**TABLE OF CHANGES FOR PLANNING
AMMENDMENTS: SECTIONS & ELEVATIONS**

SUMMARY OF CHANGES BETWEEN CONSENTED
PLANNING DRAWINGS, AS PER APPLICATION
REF 126648/FO/2020 AND RESUBMITTED PROPOSED
MMA APPLICATION DRAWINGS:

Drawing Number 6555-P-B500-E-S-001	Revision D																																																		
Drawing Status PLANNING

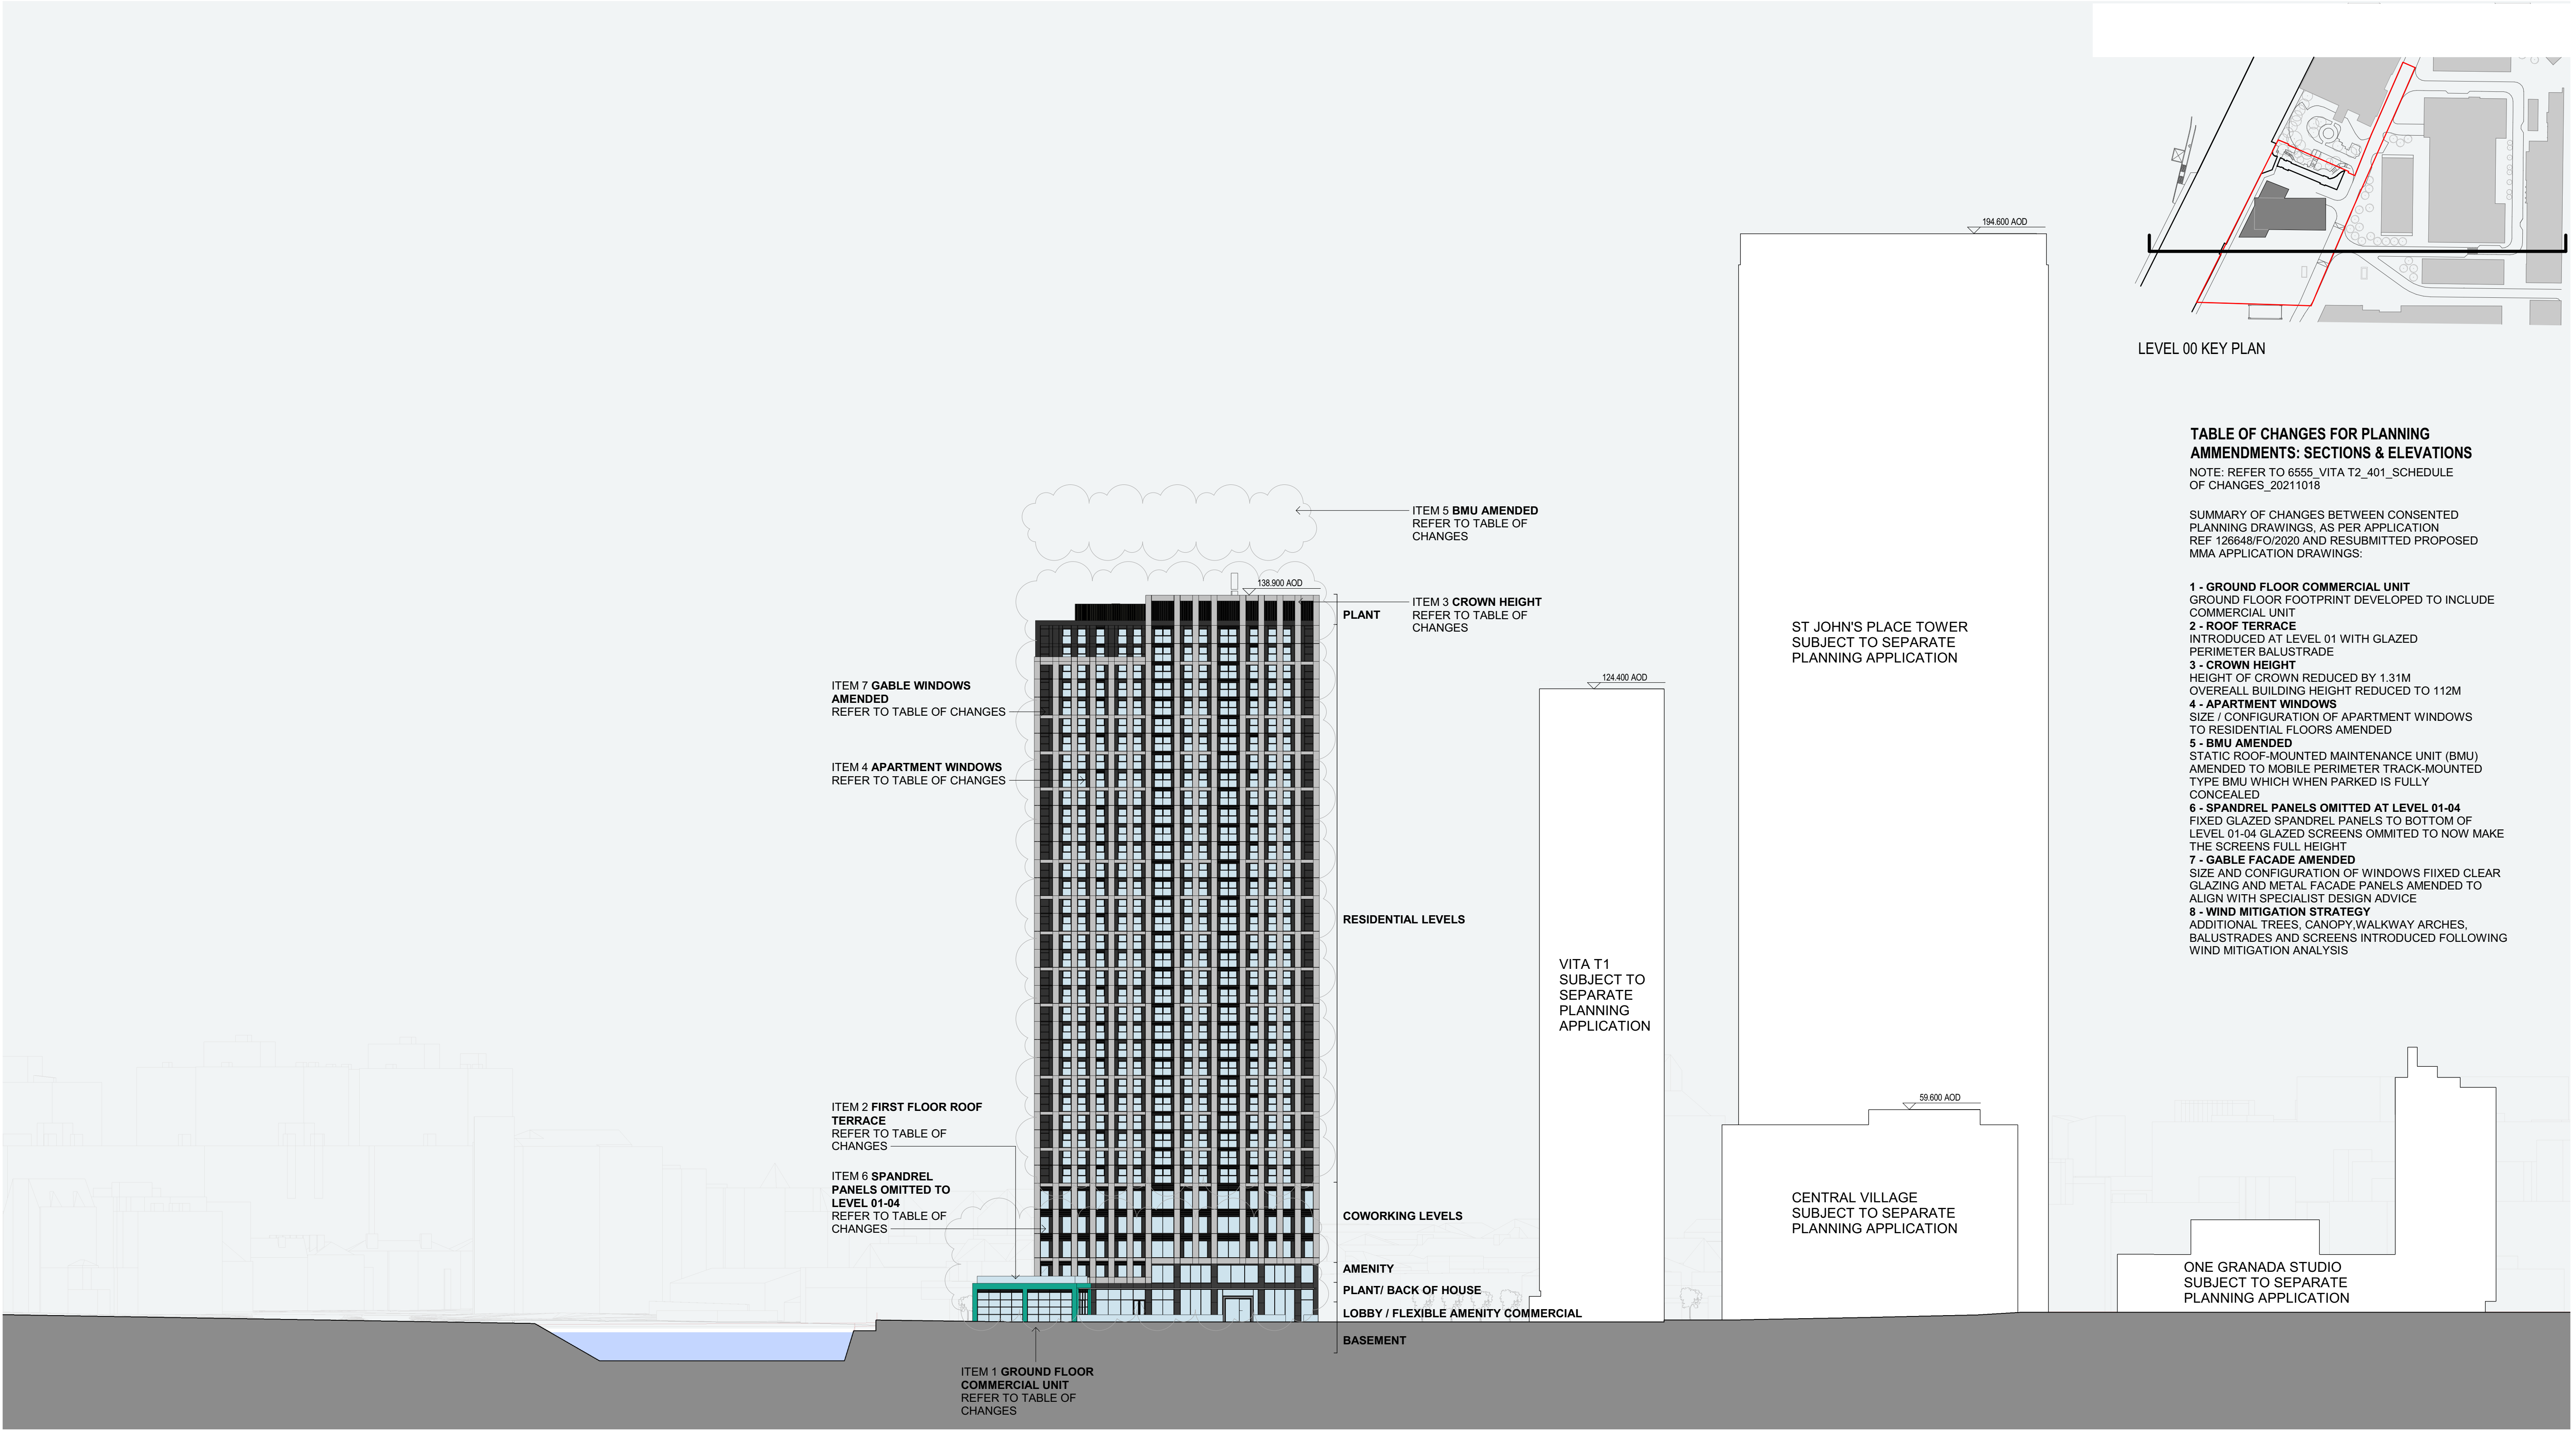
- 1 - GROUND FLOOR COMMERCIAL UNIT**
GROUND FLOOR FOOTPRINT DEVELOPED TO INCLUDE
COMMERCIAL UNIT
- 2 - ROOF TERRACE**
INTRODUCED AT LEVEL 01 WITH GLAZED
PERIMETER BALUSTRADE

- 3 - CROWN HEIGHT**
HEIGHT OF CROWN REDUCED BY 1.31M
OVEREALL BUILDING HEIGHT REDUCED TO 112M
- 4 - APARTMENT WINDOWS**
SIZE / CONFIGURATION OF APARTMENT WINDOWS
TO RESIDENTIAL FLOORS AMENDED

- 5 - BMU AMENDED**
STATIC ROOF-MOUNTED MAINTENANCE UNIT (BMU)
AMENDED TO MOBILE PERIMETER TRACK-MOUNTED
TYPE BMU WHICH WHEN PARKED IS FULLY
CONCEALED
- 6 - SPANDREL PANELS OMITTED AT LEVEL 01-04**
FIXED GLAZED SPANDREL PANELS TO BOTTOM OF
LEVEL 01-04 GLAZED SCREENS OMMITED TO NOW MAKE
THE SCREENS FULL HEIGHT

- 7 - GABLE FACADE AMENDED**
SIZE AND CONFIGURATION OF WINDOWS FIIXED CLEAR
GLAZING AND METAL FACADE PANELS AMENDED TO
ALIGN WITH SPECIALIST DESIGN ADVICE

- 8 - WIND MITIGATION STRATEGY**
ADDITIONAL TREES, CANOPY WALKWAY ARCHES,
BALUSTRADES AND SCREENS INTRODUCED FOLLOWING
WIND MITIGATION ANALYSIS
